Proposal for amendment to Regulation No. 46 (Devices for indirect vision)

The modifications to the current text of UN Regulation No. 46 are marked in bold for new characters and strikethrough for deleted characters.

II. Justification

**" Class VIII field of vision
Figure 11**

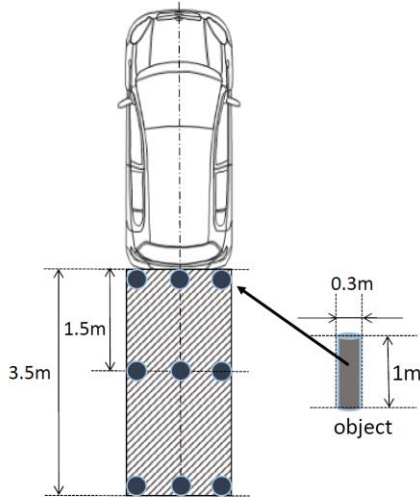
15.2.4.8.1. The field of vision shall be bounded by the following planes and shall be such that the driver can see at least part of each cylindrical objects with a height of 1,000 mm and a diameter of 300 mm which is located at 6 positions within the boundaries of the field of vision as defined in Figure.11:

(a) A transverse vertical plane of the outermost point of the rear of the vehicle;

(b) A transverse vertical plane 3,500 mm behind the outermost point of the rear of the vehicle;

(c) Two longitudinal vertical planes parallel to the longitudinal vertical median plane of the outermost point of the side of the vehicle.

Insert new Figure 11:
